State of Utah
DEPARTMENT OF NATURAL RESOURCES
DIVISION OF OIL, GAS AND MINING

RE: Site Inspection, Hecla Mining Company, Escalante Silver Mine, M/021/004, Iron County, Utah

Escalante - M/021/0C
10/18/2002 Inspectio

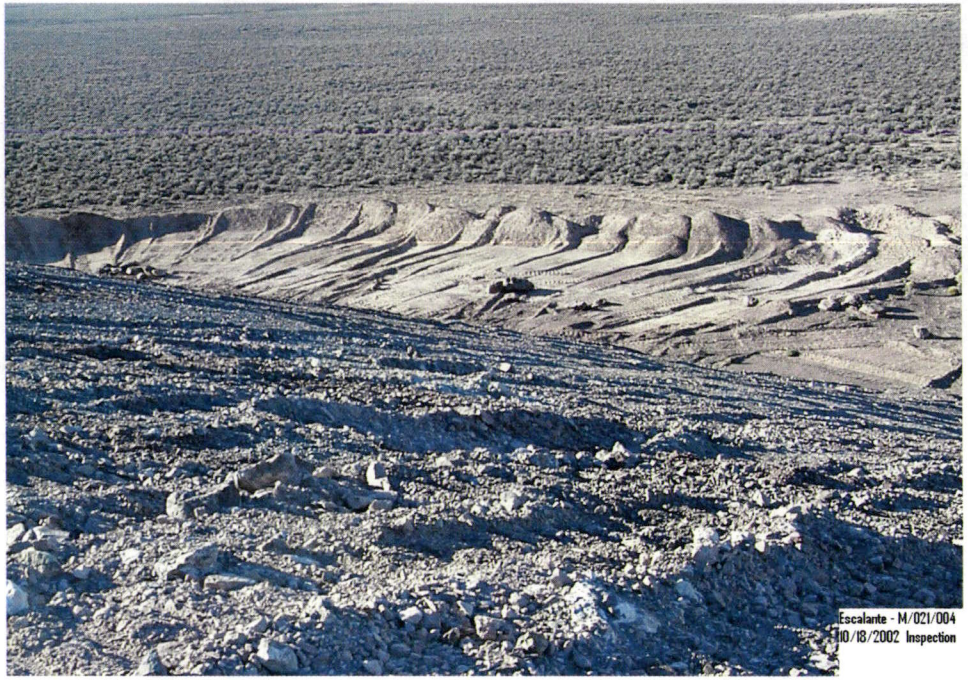
The material pile had been recontoured recently and it appears that prior to the recontouring effort some growth medium had been harvested from the area to be covered by the pile resloping. The soil harvest was not as extensive as Alan Wilson (Hecla Rep) had indicated during a previous meeting with the Division. To date, no attempt has been made to place growth medium on the reworked surface.

Because the slot was not created before resloping, it is now probable that a small borrow pit will have to be created to make up for any shortfall of growth medium.

It is the recommendation of the inspector that the growth material that is to be placed on the recontoured pile be hauled to the top of the pile and spread down the slopes. This method of material application will allow for the maximum utilization and uniform application of the growth material being placed on the final slopes.
